## LAND AT OAKLEY FARM, CHELTENHAM, NEW RESIDENTIAL DEVELOPMENT

Tuesday 5th September 2023, Cheltenham Borough Council Offices

**Housing Enabling Comments- Oakley Farm, 23/01691/REM.**

# Oakley Farm – Final Landscape Comments

**Bin storage and access**

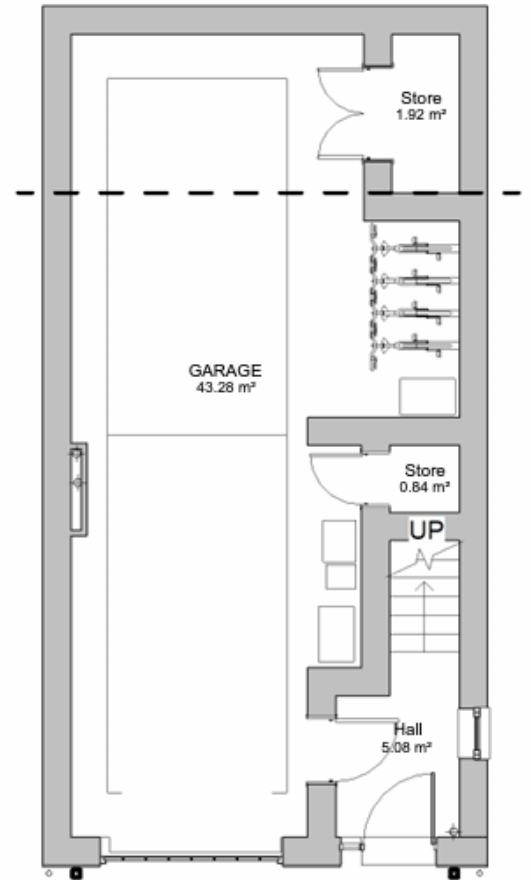
All terraced houses have front bin storage which is certainly a positive feature. We would need to see detailed plans of the construction, application of materials and sizes, to ensure that sufficient space is provided for the required bins. It might also be sensible to consider if additional storage space could be provided for EV charging cables.

1101 Front Elevation  
1 : 100

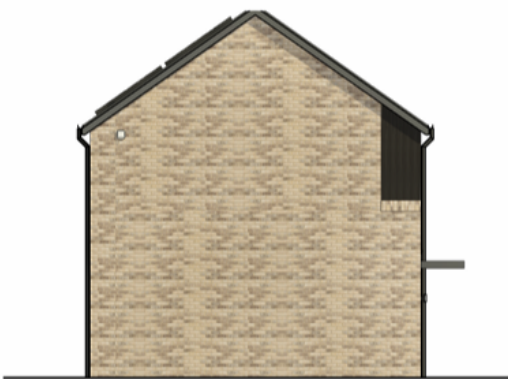
Where dark cladding is applied to the upper levels of properties, it is generally better to continue wrapping the cladding around the front and the sides (as with the Spruce Retaining GF, applied to plots 26, 28, 89 and 90, or the Chestnut No Gable type). This avoids awkward joins in prominent locations and the effect of the cladding just stopping partly around the corner, which is not a positive way to finish the effect. For example, for the mews plots including no.27 (Buckthorn), the sides should be clad, finishing into the corners. The sides, although partly concealed by the first floor amenity spaces, will still be visible as people move along the streets.

The different effects can be clearly seen within the Plot 25 (Buckthorn side balcony) elevation sheet (see below), with a more positive effect seen in the examples where cladding is applied across the whole facade.
